CITY PLAN COMMISSION

THURSDAY, MARCH 2, 2023

FILE NUMBER: S223-068 CHIEF PLANNER: Mohammad H. Bordbar

REQUEST: An application to replat a 8.843-acre tract of land containing all of Lot 3 in City Block L/8466 and a tract of land in City Block L/8466 to create three lots ranging in size from 1.320-acre to 5.650-acre on property located on Olympus Boulevard at Lock Street, northwest corner.

PRELIMINARY PLAT CYPRESS WATERS THE SOUND NO. 2 ADDITION PHASES 3 LOTS RR-RR3, BLOCK L/8466 currence analysis of the processes of the processe

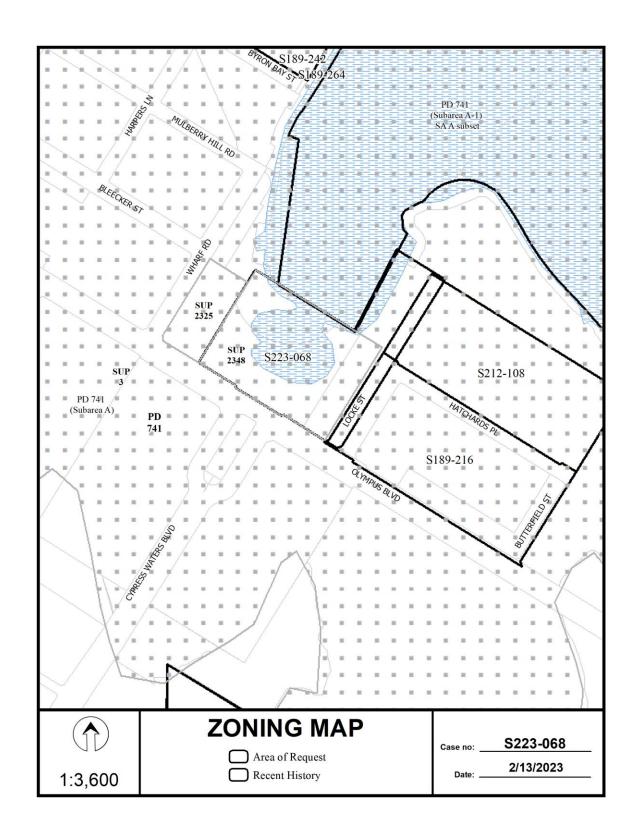
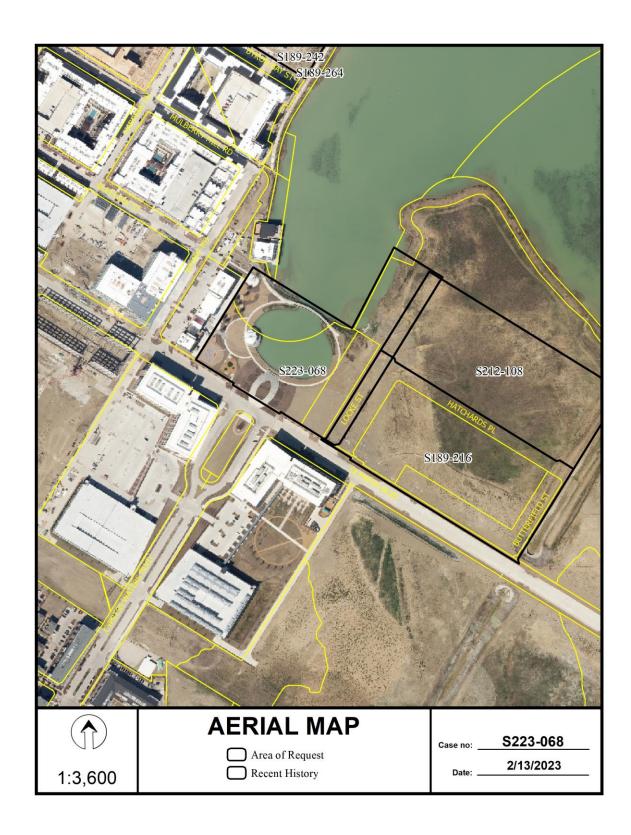
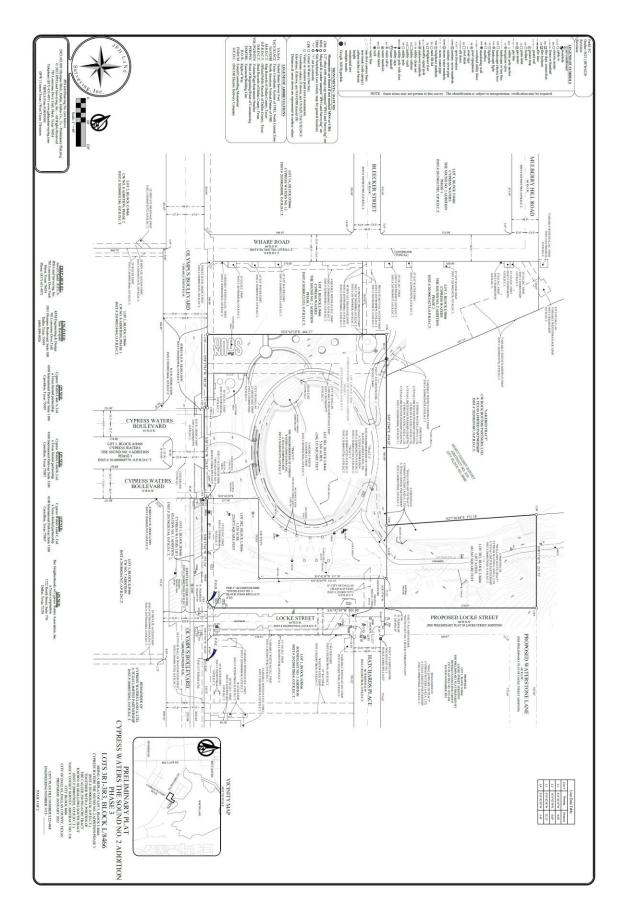
STAFF RECOMMENDATION: The request complies with the requirements of PD 741; therefore, staff recommends approval of the request subject to compliance with the following conditions:

- 2. Department of Development Services, Engineering Division must verify that the plat conforms with the water, wastewater, and easement requirements under the provisions of Chapter 49 of the Dallas City Code.

- 5. Any new or existing structure may not extend across new property lines. Section 51A-8.503(e)
- 6. On the final plat, all easement abandonments, and ROW abandonments must be by separate instrument with the recording information shown on the face of the plat. A release from the Real Estate Division is required prior to the plat being submitted to the Chairman for signature.

- 7. On the final plat, include two boundary corners tagged with these coordinates: "Texas State Plane Coordinate System, North Central Zone, North American Datum of 1983 on Grid Coordinate values, No Scale and no Projection."

- 8. On the final plat, monument all set corners per the Monumentation Ordinance. Prior to submittal of the final plat for the Chairman's signature. The monuments must be verified by the Chief City Surveyors Office in the Public Works Department. Section 51A-8.617

14. Place a note on the final plat stating "Lot-to-Lot drainage will not be allowed without proper City of Dallas Engineering Division approval" 51A 8.611(e)

- 15. On the final plat, add the note: "TxDOT approval may be required for any driveway modification or new access point(s)." No citation.
- 16. Existing drainage conveyance within the property is required to be sized in compliance with Section 51A-8.611(a)(1) of the City of Dallas Code.

- 17. On the final plat, determine the 100-year water surface elevation across this addition.
- 18. On the final plat, dedicate floodway easement, floodway management area or floodway easement (within common area), with the appropriate easement statement included on the face of the Plat. <u>51A 8.611(d)</u>; <u>DWU Floodplain Management</u>; <u>Drainage Design Manual Addendum V</u>

- 20. On the final plat, specify minimum fill and minimum finished floor elevations. Section 51A-8.611(d), Trinity Watershed Management.
- 21. On the final plat, show the natural channel set back from the crest of the natural channel. Section 51A-8.611(d), Trinity Watershed Management.

- 24. Prior to final plat, submit a completed final plat checklist and all supporting documents.
- 25. On the final plat, chose a new or different addition name. Platting Guidelines.

- 26. Engineer must furnish plans for water and sanitary sewer. Developer must furnish a contract for water and sanitary sewer. Sections 49-60(g)(1) and (2) and 49-62(b), (c), and (f).
- 27. Additional design information is required for assessment. Site plan must be submitted showing proposed development, building finished floor elevation, development, existing mains including downstream manhole, and proposed water and wastewater service locations. Submit water/wastewater engineering

- 29. Prior to final plat, remove all instances of "Proposed"
- 30. Prior to final plat, contact the Addressing Manager to obtain appropriate name for the proposed public street. Sections 51A-8.403(a)(1)(A)(xii)
- 31. On the final plat, identify the property as Lots 3A-3C in City Block L/8466. Ordinance 1A, Page 131 pages 131-148, Section 2 (passed August 13, 1872).
